Agenda – Executive Policy Committee – July 6, 2016

Title: SPA 3/2016, Amendment to the Bishop Grandin Crossing Area Master Plan

Issue: The property owner is proposing to make minor amendments to the Area Master Plan approved by Council in 2014 to reflect a realignment of the road network and to accommodate all drainage requirements on-site.

APPENDIX A: PLANNING DISCUSSION

Figure 1: Bishop Grandin Crossing Site Location and Context, showing proposed amendments

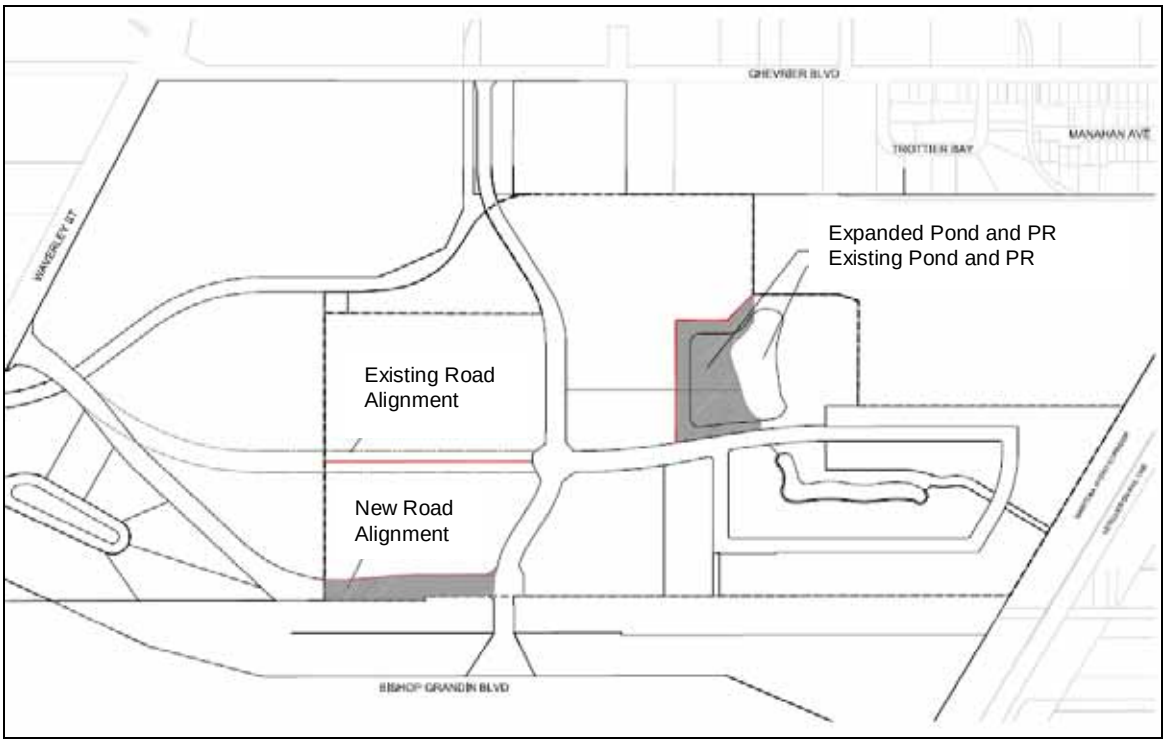
The applicant has indicated that an intent of the application is to request a change to the alignment of the Scurfield Boulevard Extension. Hopewell would like to use the existing, right-of-way (ROW), and no longer requires the realignment of the ROW further north that was endorsed by Council as part of the Area Master Plan under SP 1/2014 (see Figure 1 above). In addition, Hopewell would like to 'widen' the proposed stormwater retention pond to the west, north of Ballantrae Drive (PR "A"). The pond has now been sized accordingly to accommodate on-site storage requirements.

The proposed change to the roadway alignment comes about due to an issue experienced in acquiring land for the westerly extension of Ballantrae Drive to Waverley Boulevard. The original Area Master Plan contemplated a four-legged intersection at Newmarket and Ballantrae, however, lands west of the Sugar Beets site are owned by Manitoba Hydro and contain an active storage yard. Hydro was not willing, at this time, to release these lands for redevelopment, exchange and the roadway extension. As a result, Hopewell is proposing to revert to the option of the existing Scurfield right-of-way which is legally available, but not currently opened or constructed as a street along the south boundary of the MRS.

In the future, the westerly extension of Ballantrae at Newmarket is proposed to be a private street serving adjacent development. For the time being, the intersection would function as T-intersection. A new roundabout is proposed at the intersection of Scurfield and Newmarket with size and actual location to be determined as part of the detailed engineering work.

The proposed change to the retention pond and associated park lands north of Ballantrae Drive is necessitated by the need to accommodate all drainage requirements on-site rather than acquiring additional lands outside the site to the west for a third retention pond. Expansion of the northerly pond was viewed as the best option to consolidate land drainage facilities and maximize infrastructure efficiencies while at the same time enhancing open space, pathways and recreational uses in the vicinity. The required expansion of the pond reduces the developable area of the site by about 5 acres and extends into land formerly designated as industrial and commercial mixed use. The additional impoundment lands will be dedicated to the City as Public Reserve through the subdivision process (under separate application). Pathways will now extend around the full expanse of the pond.
